**Proposed Minor Relaxation of Building Height Restriction
for Permitted Flat in "Residential (Group A) 1" Zone,
Lot Nos. 2268 S.A, 2268 RP, 2269RP, 2270 RP, 2271, 2272, 2273 S.A RP, 2273 S.B ss.2,
2273 S.B ss.3, 2273 S.B ss.4, 2273 S.B RP, 2273 S.C ss.2, 2274, 2275 in DD120 and
Adjoining Government Land, Kung Um Road, Yuen Long, N.T.
(Planning Application No. A/YL/331)
Further Information No. 1**

**Proposed Minor Relaxation of Building Height Restriction for Permitted Flat in
“Residential (Group A) 1” Zone at Various Lots in D.D. 120 and
Adjoining Government Land, Kung Um Road, Yuen Long
(Planning Application No. A/YL/331)**

Comments				Responses
Comments from District Planning Officer / Tuen Mun & Yuen Long West, Planning Department (received on 11 May 2026) (Contact: Ms Carmen CHEUNG; Tel.: 2158 6333)

Figure 3.1 Proposed Design Measures

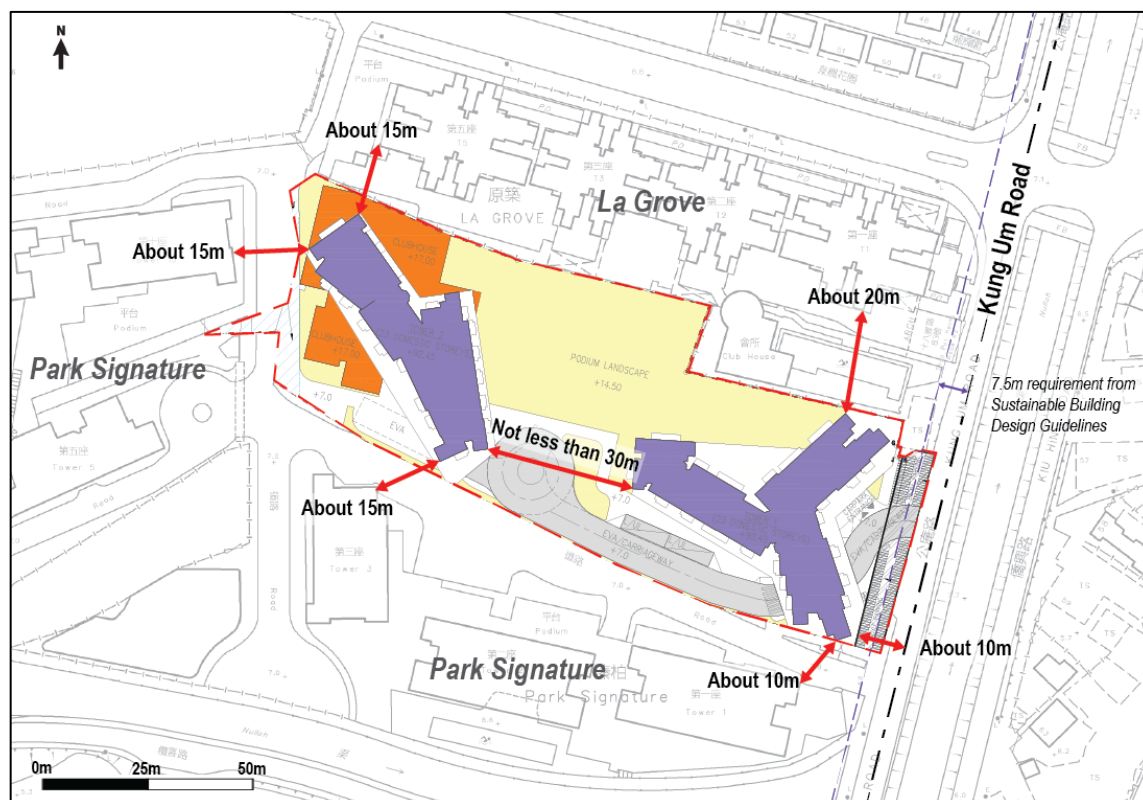
(i) Please submit drawing(s) (and further written explanation where applicable) showing the proposed design measures as indicated in the supplementary planning statement section 3.2.				The proposed design measures have been included in the updated Supporting Planning Statement.
(ii) When compared with the OZP conforming scheme, it is observed that the floor-to-floor height (FTFH) of G/F and 1/F of Tower 2 has increased from 5m to 6.25m, while the FTFH of G/F of Tower 1 has increased from 5m to 7.5m, hence an overall increase of 2.5m in absolute building height for both towers. Please provide justifications on why an increase of 1.25m each at G/F and 1/F of Tower 2, and 2.5m at G/F of Tower 1 is required in the proposed scheme.				Upon further review, the FTFH of G/F and 1/F of Tower 2 for the Proposed Scheme has been adjusted from 6.25m to 5m. For Tower 1, the increase in FTFH of G/F from 5m to 7.5m is required to accommodate the additional level of carpark (each with a FTFH of 3.75m). Upon the adjustment, the building height (at main roof) of the Proposed Scheme would be reduced to 92.45mPD, which is the same as that of the Conforming Scheme (Appendix 1 refers).
